RESPONSES TO COMMENTS

Stonestown Development Project

San Francisco Planning
Case No. **2021-012028ENV**
State Clearinghouse No. 2022040571

Date: April 24, 2024
Case No.: **2021-012028ENV**
Project Title: **Stonestown Development Project**
To: Members of the Planning Commission and Interested Parties
From: Lisa Gibson, Environmental Review Officer
Re: Attached Responses to Comments on Draft Environmental Impact Report for the Stonestown Development Project (Planning Department File No. 2021-012028ENV)

FIGURE 2-12
PROPOSED STREET PLAN (REVISED)

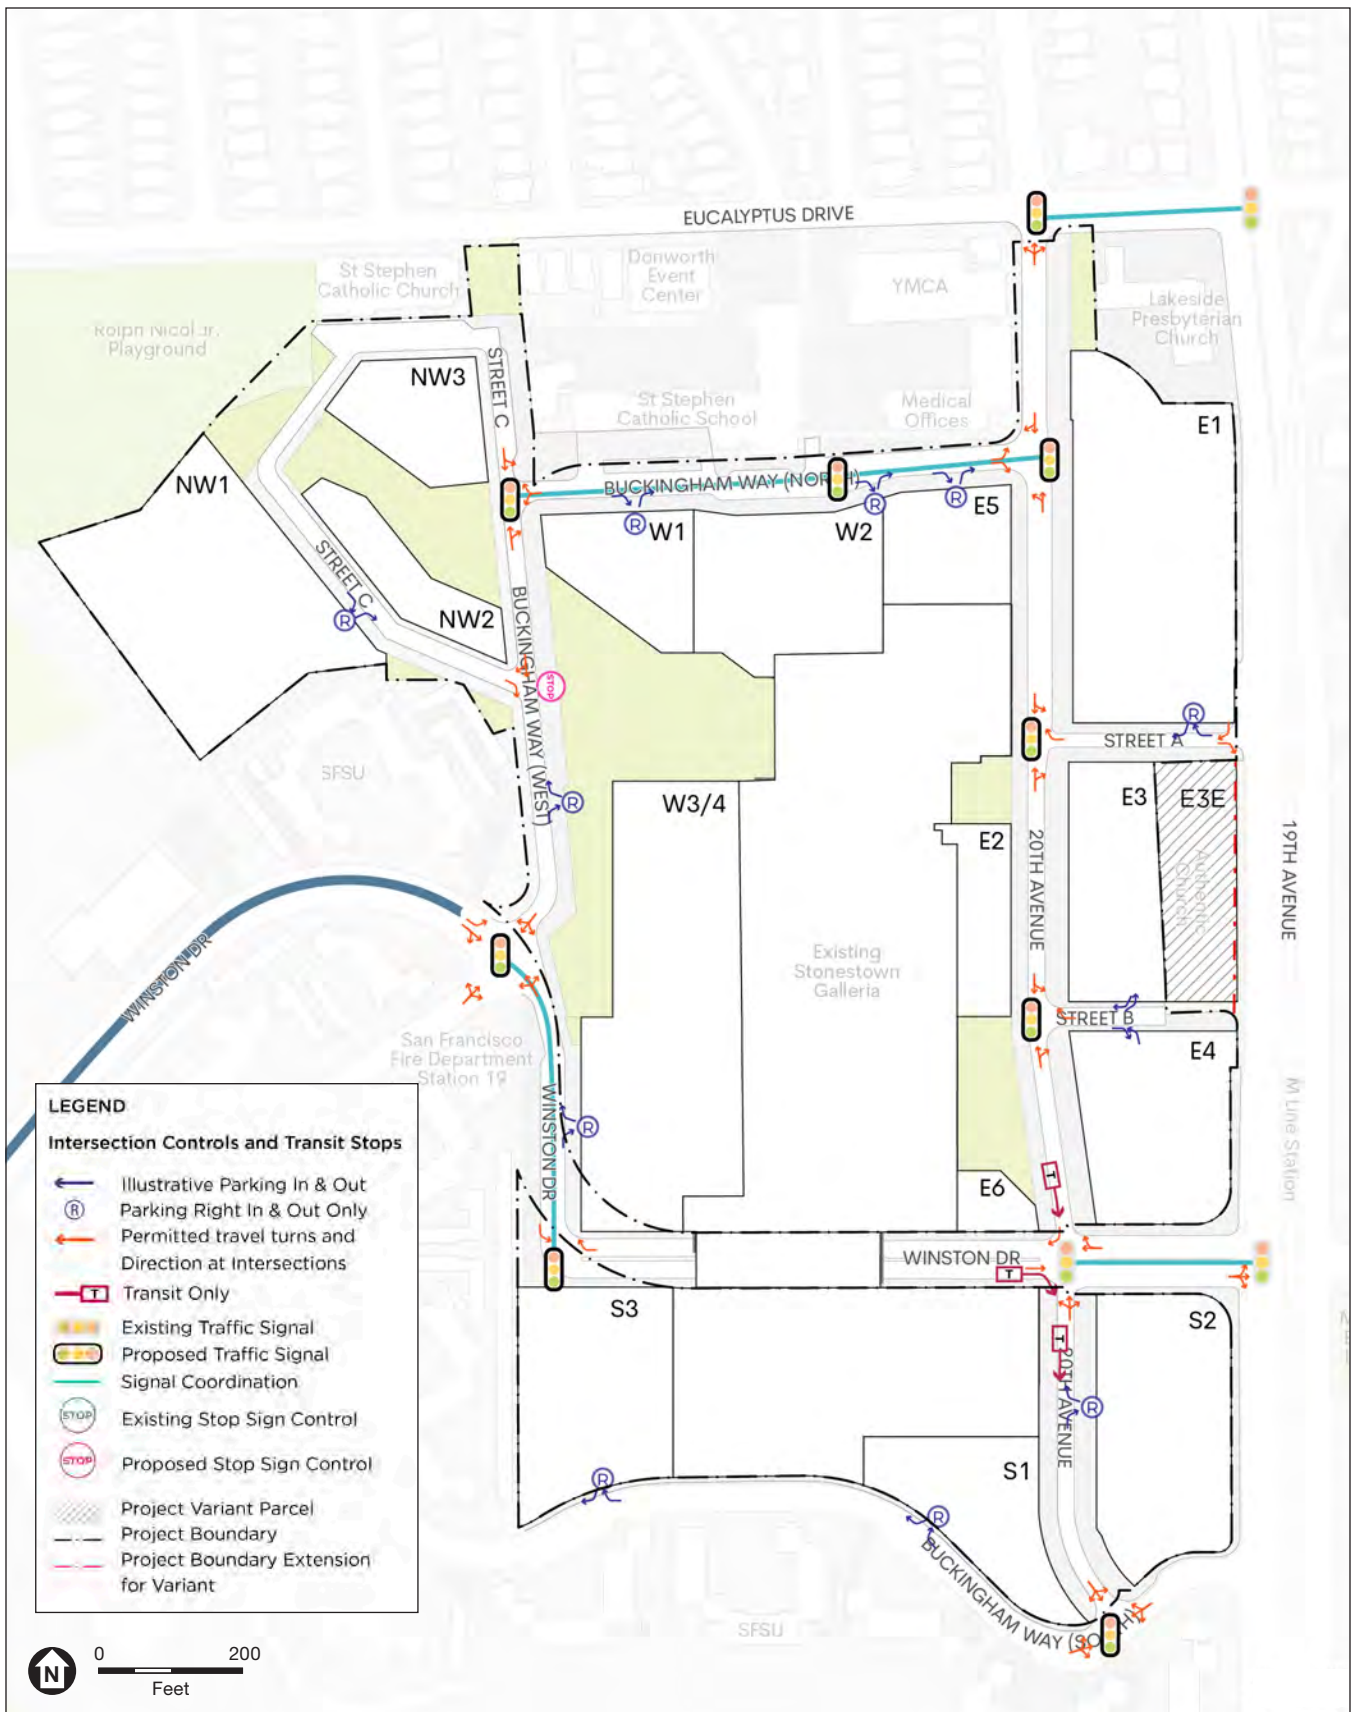
Page 2-20, Section 2.D.8, bullet #1. The text indicates that 20th Avenue would have two travel lanes (one lane in each direction) between Eucalyptus and Winston Drives. This is not consistent with Figure 2-12 on page 2-22, which shows this segment of 20th Avenue as having two travel lanes in each direction. Which is it? What was used in the travel analysis and trip generation?” (*Dave Full, Letter, 2/12/2023 [I-Full-3, PD-1]*)

Page 2-28, bullet #1. The description on the number of travel lanes on Buckingham Way between 20th Avenue and Winston Drive is not consistent with Figure 2-12 on page 2-22 or Figure 2-18 on page 2-29.

Comments state that the description of 20th Avenue on draft EIR p. 2-20 is not consistent with Figure 2-12 on p. 2-22. The analysis in the transportation and circulation section is based on the changes proposed by the proposed project or variant shown in Figure 2-12 and Figure 2-13, as noted on draft EIR p. 3.B-24. In response to these comments, the last bullet point on draft EIR p. 2-20 was revised as follows to clarify the range of travel lanes on 20th Avenue:

One comment states that the description of the number of travel lanes on Buckingham Way between 20th Avenue and Winston Drive is not consistent with Figure 2-12 and Figure 2-18 on draft EIR pp. 2-22 and 2-29, respectively. In response to the comment, the first bullet on draft EIR p. 2-28 was revised as follows to clarify the range of travel lanes on Buckingham Way:

FIGURE 2-13
PROPOSED INTERSECTION CONTROLS (REVISED)

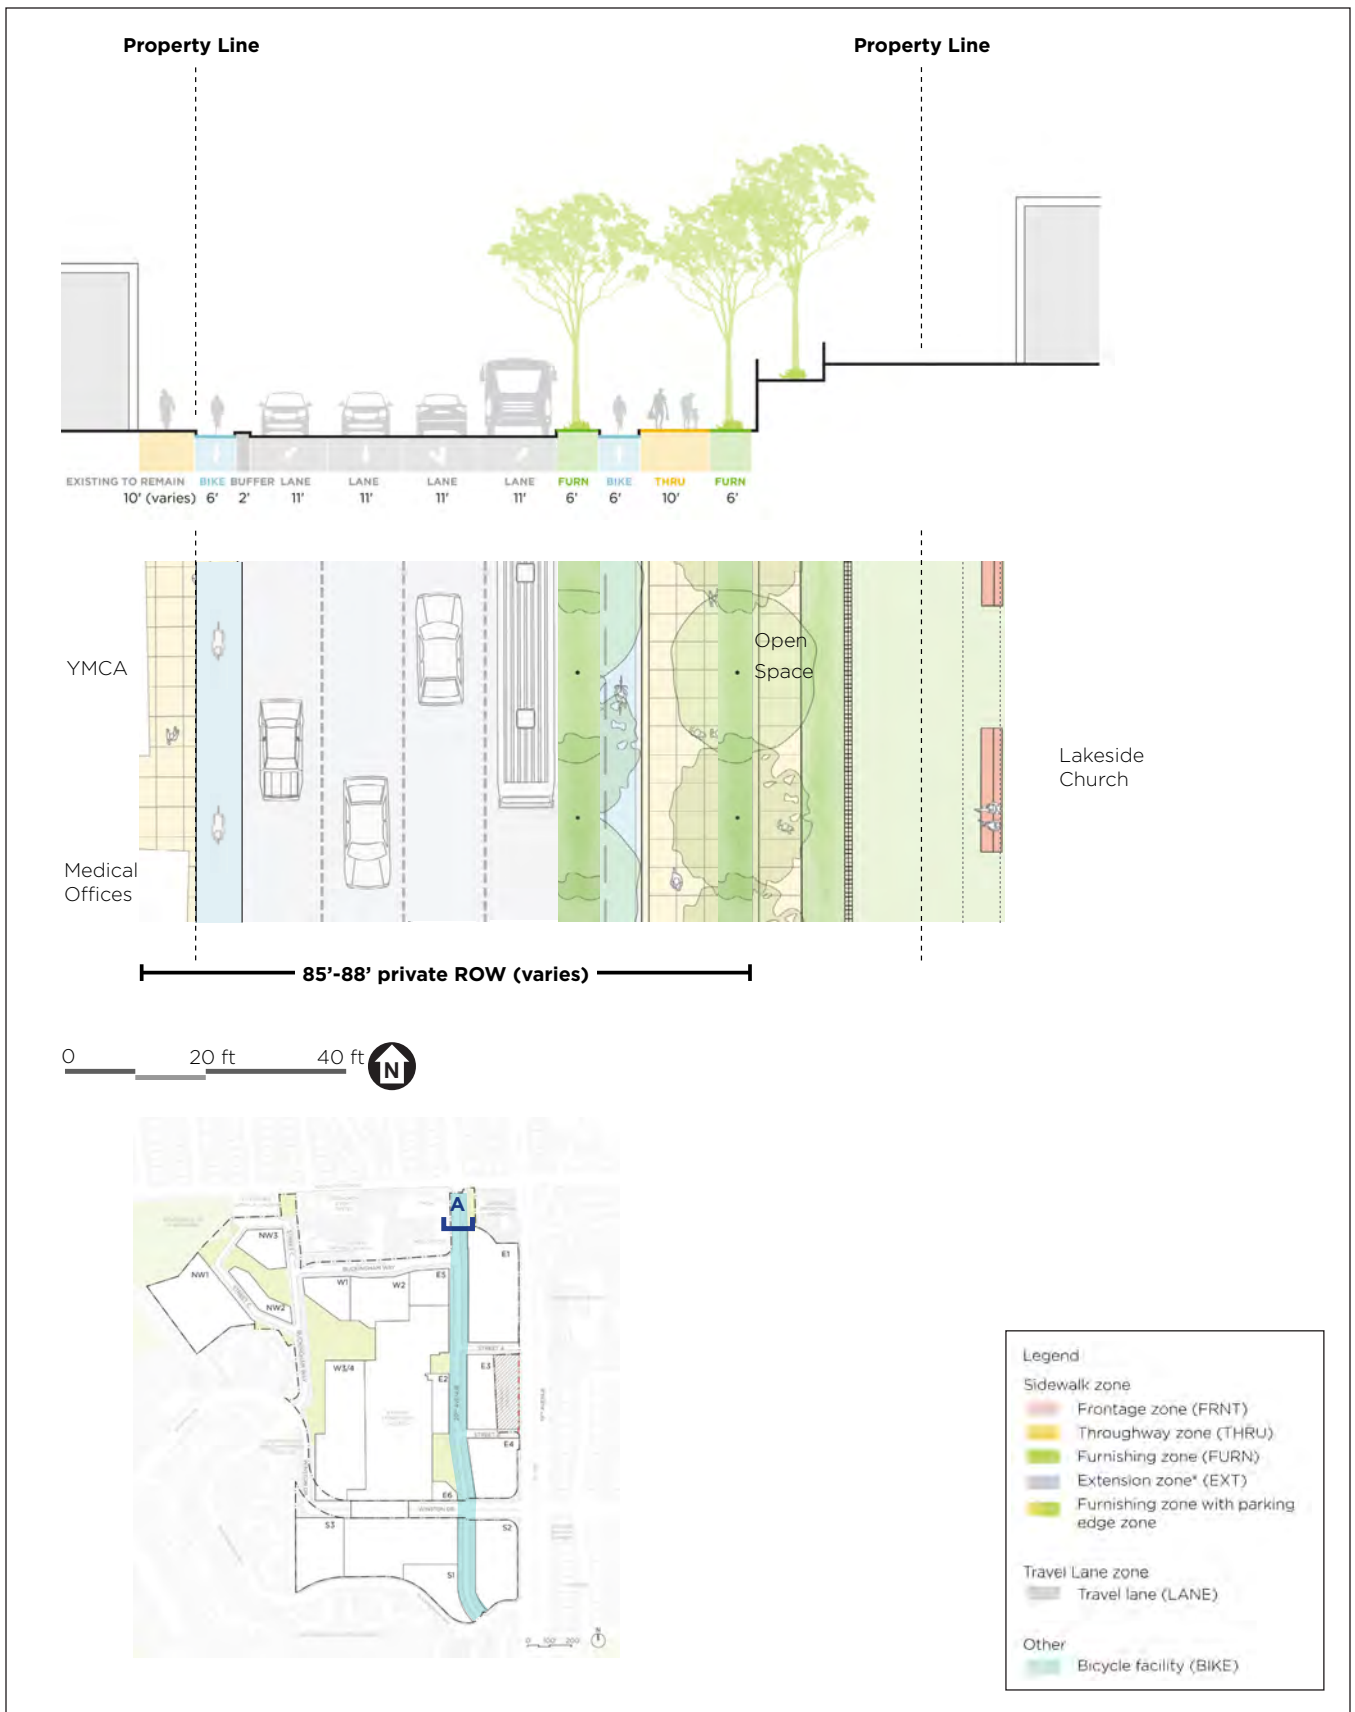
Page 2-28, paragraph 2. This paragraph indicates that there will be a traffic signal at Buckingham Way and Winston Drive. However, Figure 2-13 on page 2-23 indicates that this will be a stop-sign-controlled intersection. Which is it? What was assumed when doing the traffic analysis in the EIR?” (Dave Full, Letter, 2/12/2023 [I-Full-5, PD-1])

“Page 2-23, Figure 2-13. This figure shows a traffic signal at the intersection of Eucalyptus Drive and 20th Avenue. Was a traffic signal warrant study conducted for this intersection to determine that a traffic signal is needed? Where is the result of that study in the EIR? Also, the intersection of Buckingham Way and Winston Drive is proposed to continue to be a stop-sign-controlled intersection. Given that the traffic volumes at this

Comments request clarification regarding the traffic signal at Buckingham Way and Winston Drive. A traffic signal is proposed at Buckingham Way and Winston Drive. Figure 2-13 on draft EIR p. 2-23 has been corrected (see p. 5-36). A signalized intersection is assumed in the traffic analysis in the EIR, as noted on draft EIR p. 3.B-25 in the last bullet above the heading “Walking Network Features.”

5-37 **FIGURE 2-14**
20TH AVENUE ILLUSTRATIVE SECTION A (REVISED)

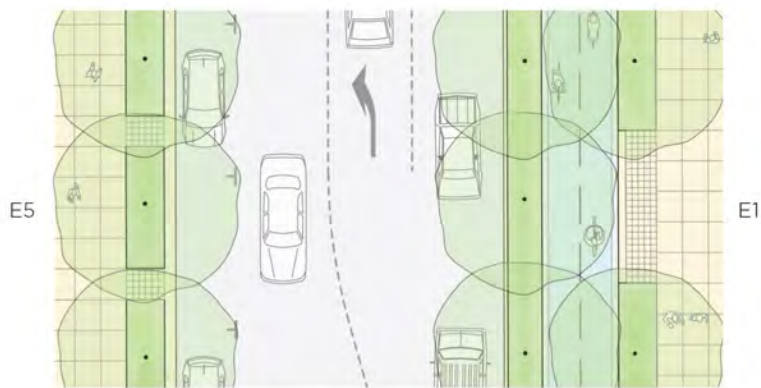
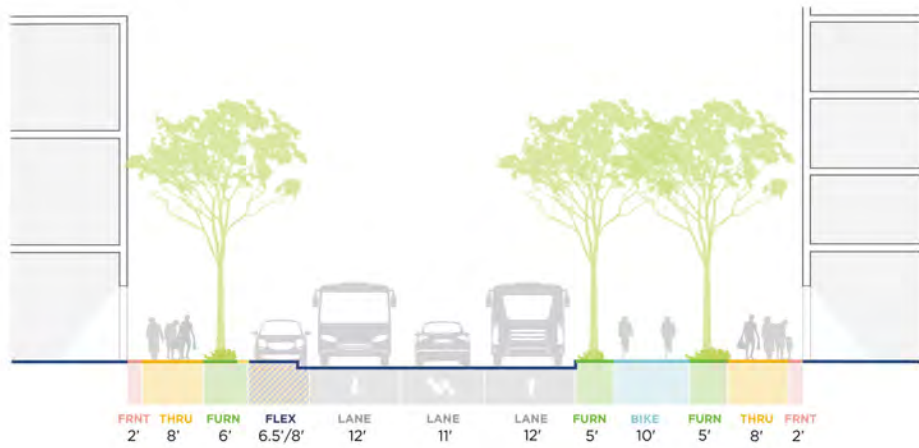
“Page 2-24, Figure 2-14. This figure shows that 20th Avenue would have two travel lanes in the southbound direction and one travel lane in the northbound direction. This is not consistent with Figure 2-12 on page 2-22, which shows this segment of 20th Avenue as having two travel lanes in each direction, or with the text presented on page 2-20.

In response to comments regarding Figure 2-14 on draft EIR p. 2-14, these are noted as conceptual illustrative street sections. Figure 2-14 on draft EIR p. 2-14 has been updated to reflect project sponsor updates and to address the comments (see p. 5-37).

FIGURE 2-23
PROPOSED POTABLE WATER PLAN (REVISED)

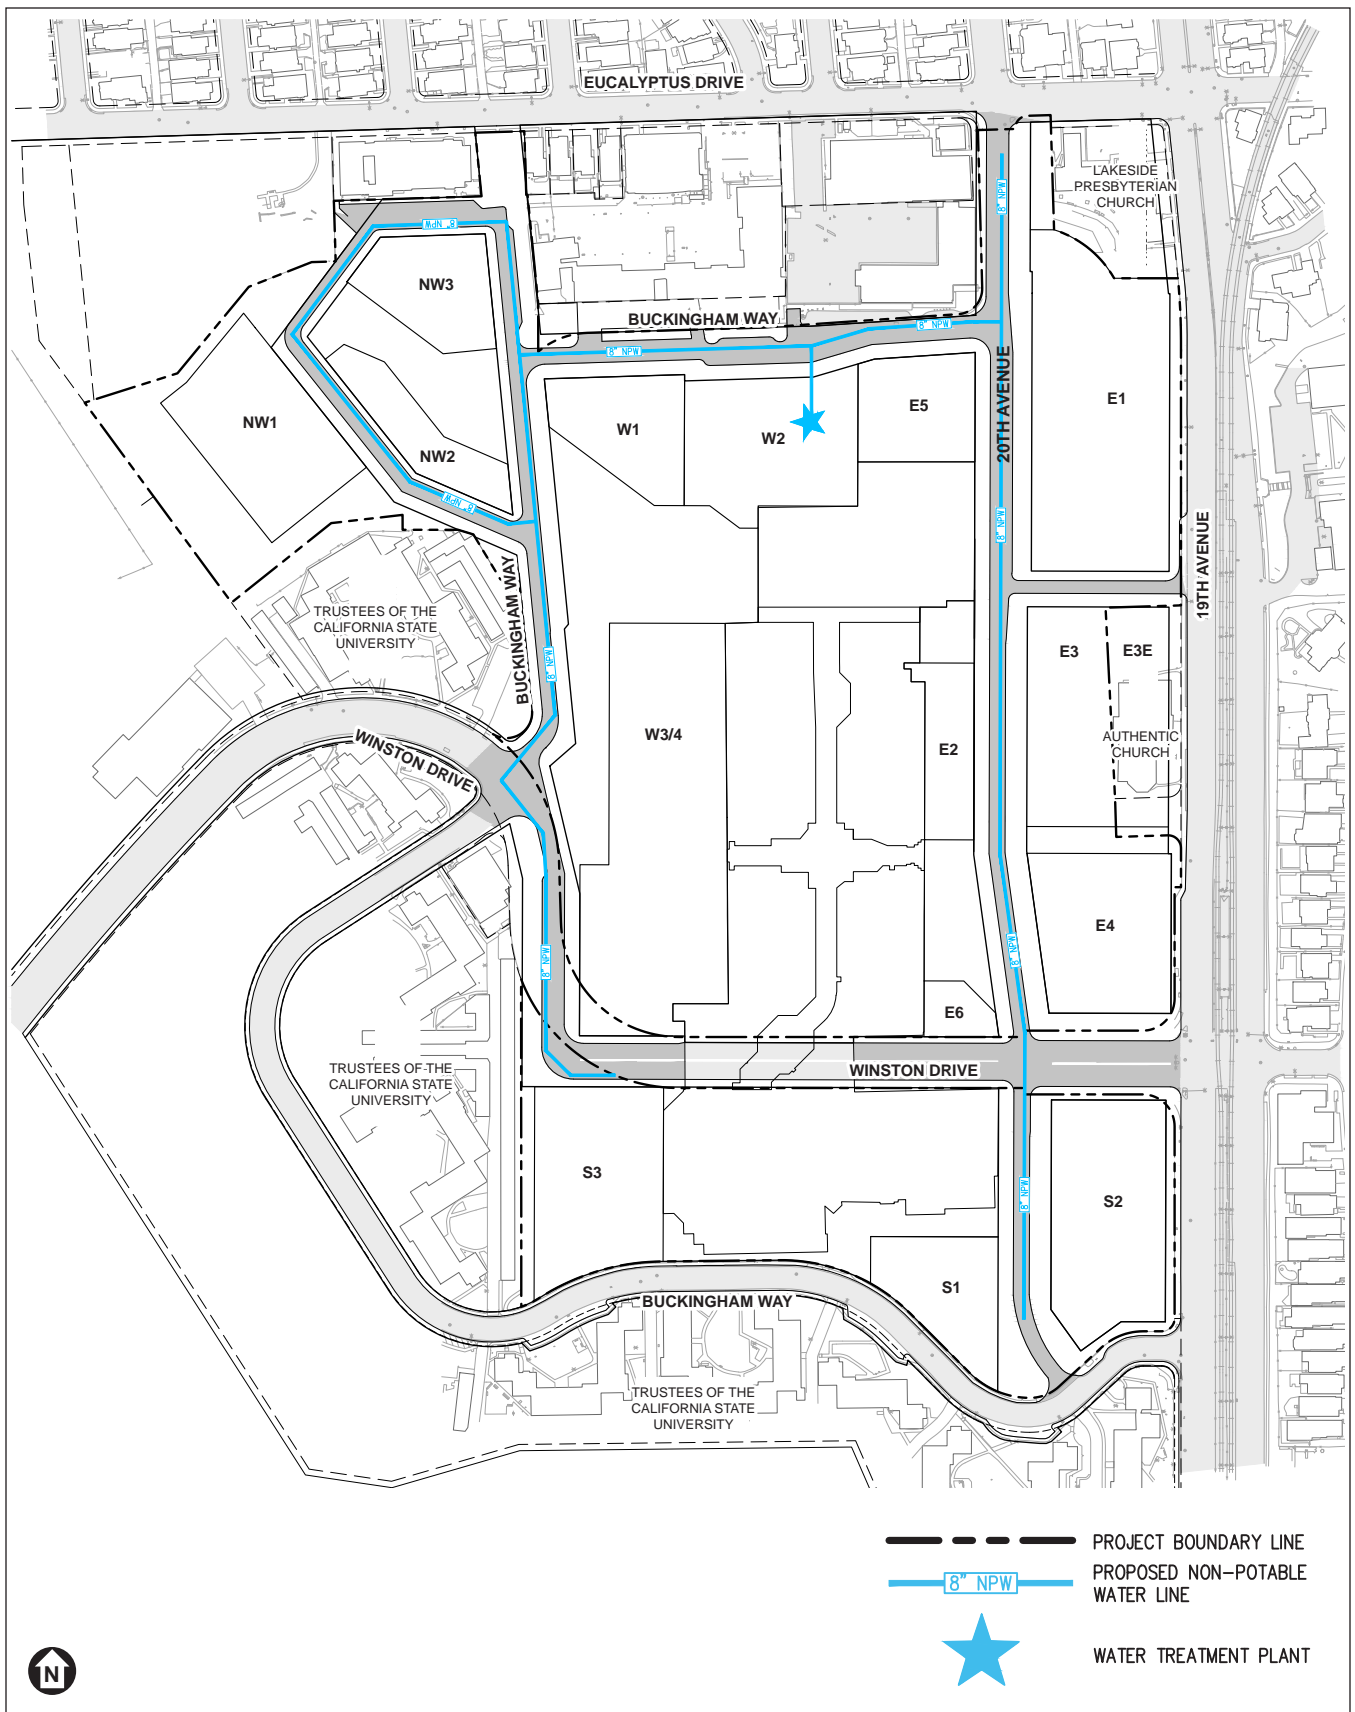
- Figure 2-22: the road approach and road connection off the State Highway System for the new streets
 - Figure 2-23: the new proposed water line within the limits of Caltrans’ Right of Way (ROW)
 - Figure 2-26: the new private sewer line within the limits of Caltrans’ ROW
 - Figure 3.B-4: the proposed sidewalks within the limits of Caltrans’ ROW” (*Yunsheng Luo, Associate Transportation Planner, California Department of Transportation, Letter, 2/8/23 [A-Caltrans-1, GC- CEQA-6]*)
-

The comment requests coordination of the proposed project design and construction schedule with Caltrans projects specified in the comment and identifies project elements depicted in draft EIR Figures 2-22, 2-23, 2-26, and 3.B-4 that would require a Caltrans-issued encroachment permit. The comment is acknowledged. The proposed project or variant would include the requested coordination of the project design and construction schedule with the identified Caltrans projects and coordination regarding the required encroachment permits. Also note that draft EIR Section 2.G, Required Project Approvals (see Section 2.G.1, State and Regional Agencies, California Department of Transportation, p. 2-47), identifies the Caltrans encroachment permit requirement.
